**CERTIFICATE OF APPROPRIATENESS**

**Property:** 1610 Cortlandt Street, tract 15A and 16A, block 115, Houston Heights Subdivision. The property includes an original one-story bungalow with partially completed two-story rear and side addition on an 8,246 square foot (62' x 133') interior lot.

**Proposal:** Alteration – Revisions to a COA for a two-story rear and side addition.

**STAFF SITE VISIT PHOTO 7/21/14**

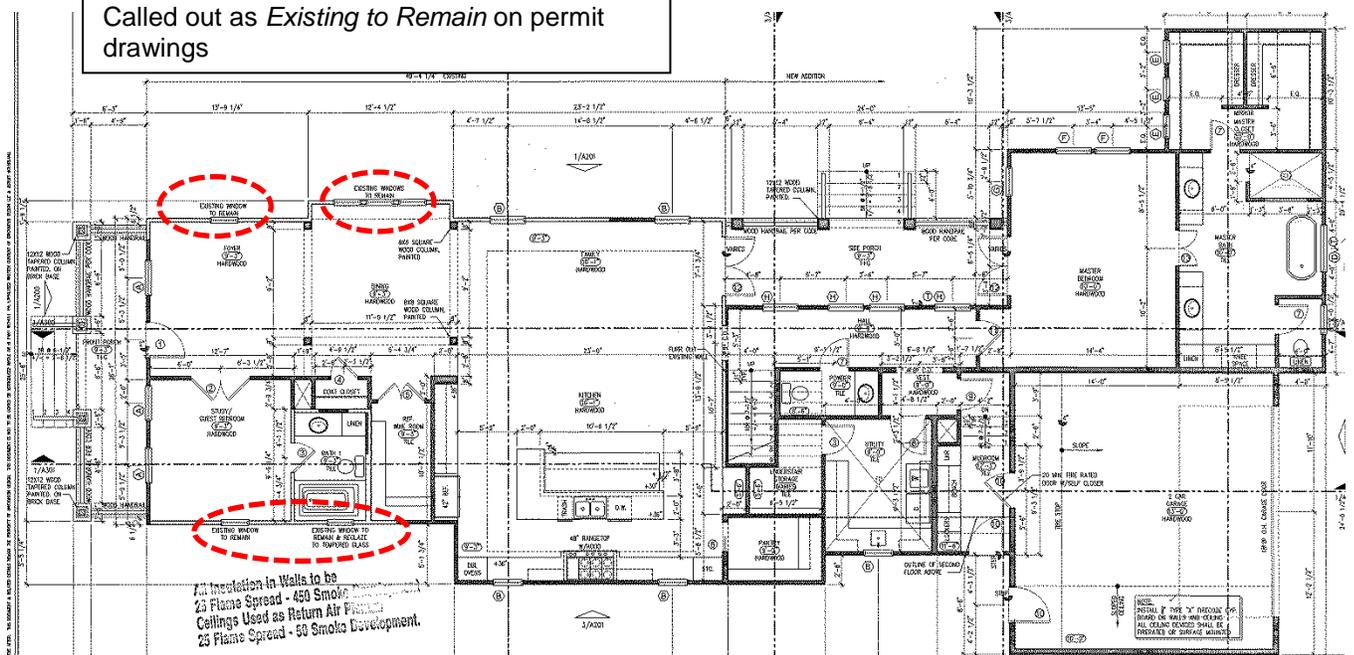
NEW SIDING AND 4 OVER 1 WINDOWS INSTALLED

4 over 1 windows used instead of 1 over 1

Salvaged historic 117 siding (painted grey) installed alongside new siding. . Applicant asserts that the siding towards the front of the house was from an earlier alteration to enclose the front porch.

NEW SIDING AND 4 OVER 1 WINDOWS INSTALLED

4 over 1 window used instead of 1 over 1

Salvaged historic 117 siding (painted grey) installed alongside new siding. Applicant asserts that the siding towards the front of the house was from an earlier alteration to enclose the front porch.

FIRST FLOOR PLAN

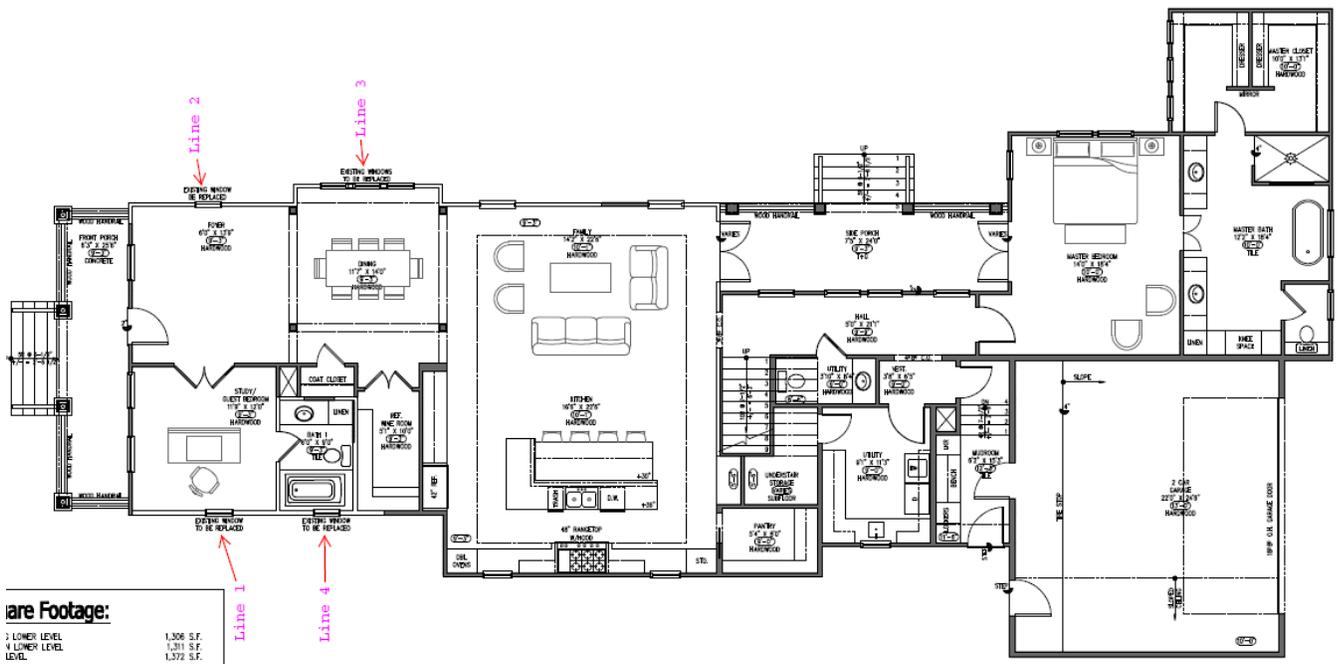
Called out as *Existing to Remain* on permit drawings

NEW 4 OVER 1 WINDOWS INSTALLED

**PHOTO OF EXISTING WINDOWS DURING CONSTRUCTION TAKEN 5/6/14**

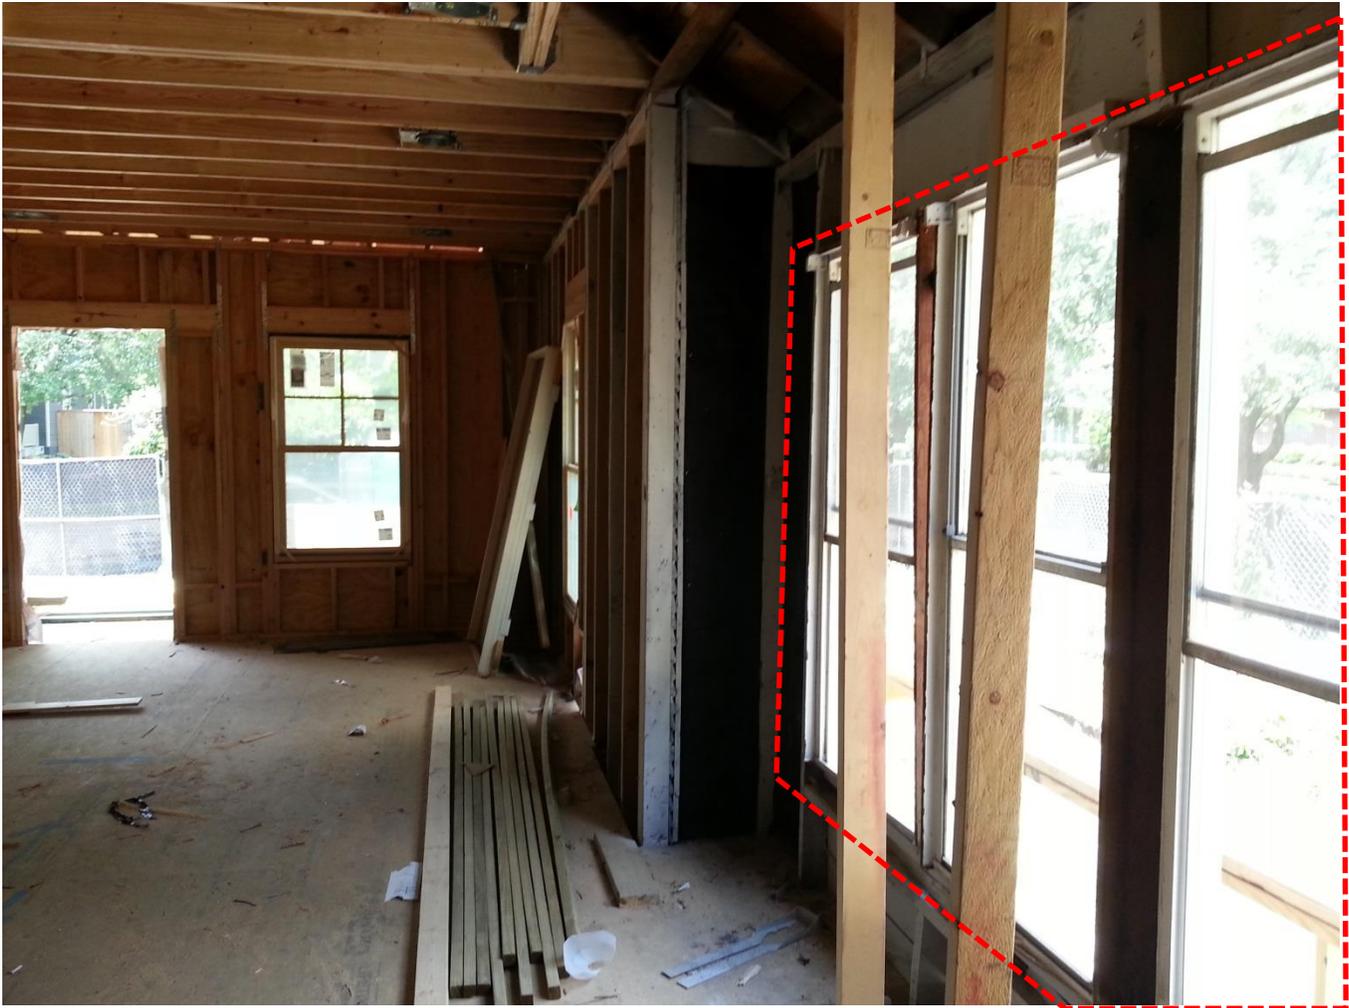
THESE APPEAR TO BE NON-ORIGINAL METAL WINDOWS
